SERVICE BULLETIN

Bulletin No: JC-13-18

Product Type: STEINER

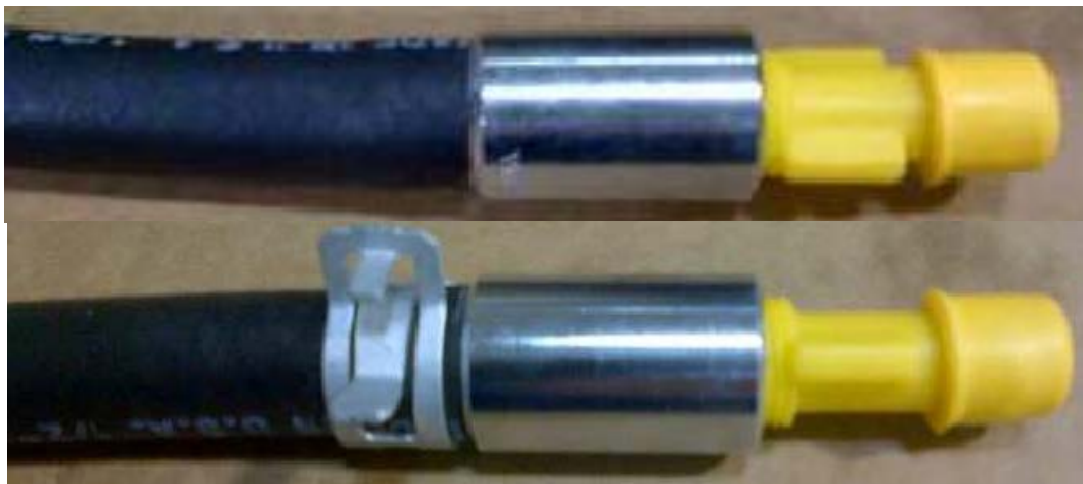
Customer Issue: The valve on the end of the Kubota engine oil drain hose can be removed too easily and cause a possible oil loss.

Cause: There is no hose clamp to hold the valve tight in the hose.

Action required: Install a hose clamp on the engine oil drain hose.

7572010 Kubota diesel tractors order a hose clamp: 88042-05

7572011 Kubota gas tractors order a hose clamp: 88042-03
